TO: DEVELOPMENT REVIEW BOARD
FROM: CURRENT PLANNING SERVICES
SUBJECT: CASE 54-DR-2003
REQUEST: Approve site plan and elevations for an oil change facility
PROJECT NAME: Chevron Oil Stop
LOCATION: 7555 E Camelback Rd

DATE: October 23, 2003

1 SITE DEVELOPMENT PLAN

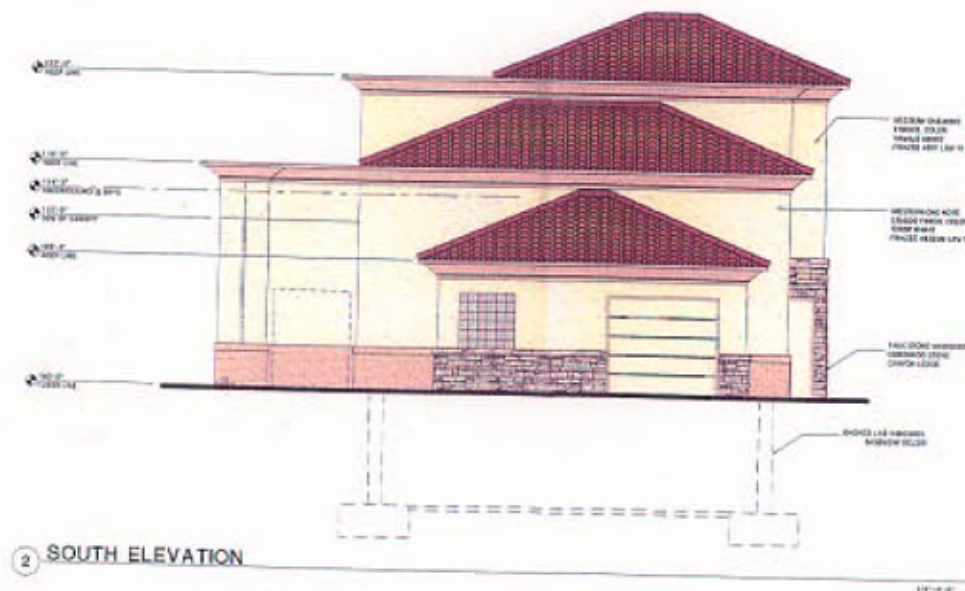
- A. Where the two feet parking overhang is used, the landscaped area between the curb and property line shall not be less than 3.5' wide.

- B. The van accessible parking space shall be universal design, having an 11' stall width and 5' access width. The access aisle shall be on the right side of the space. The ramp and accessible path shall be relocated and reconfigured to accommodate the universal design.

CONCEPTUAL LANDSCAPE PLAN

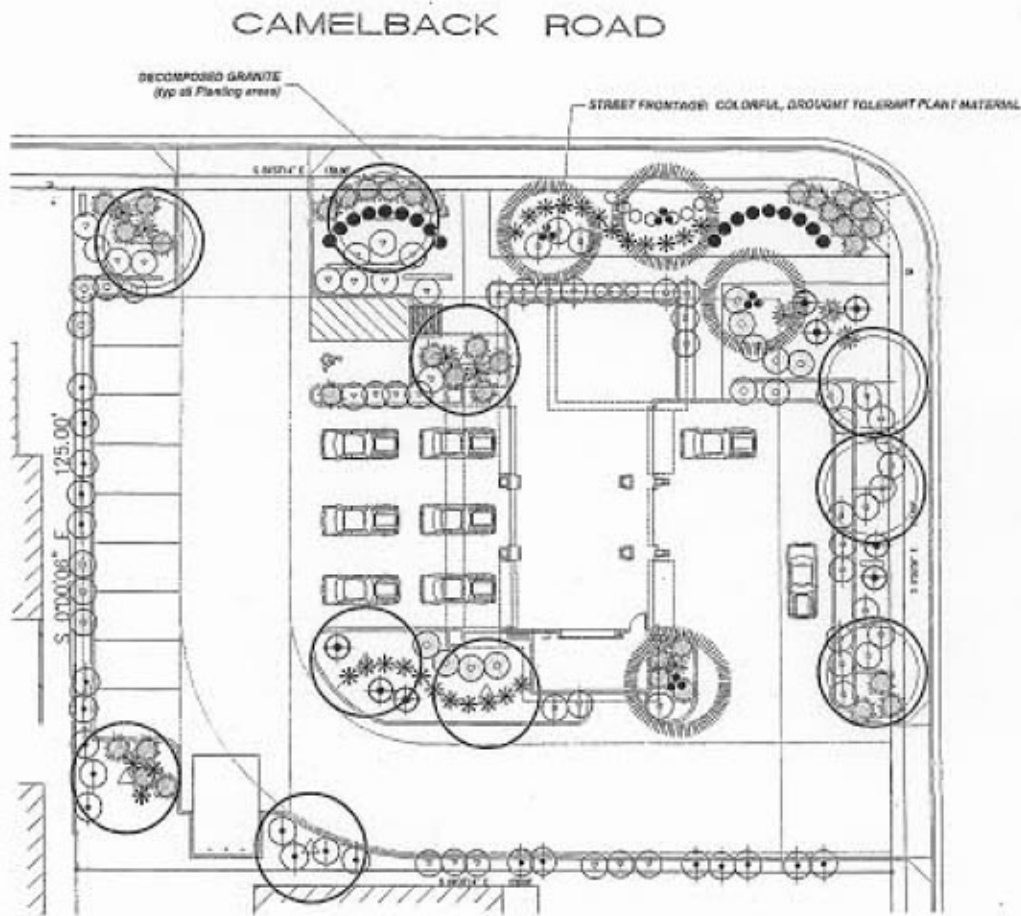
9. Areas of parking overhang shall contain plant species having mature heights and planting locations that are not impacted by vehicle overhang.

- C. Decomposed granite shall be installed with a two-inch minimum depth.
- D. A minimum of 50% of proposed trees shall be mature as defined in Article III of the Zoning Ordinance.
- E. Areas in decomposed granite shall not exceed seven feet between plant canopies.
- F. Landscaped areas in the rights-of-way adjacent to the subject property shall be maintained by the property owner.
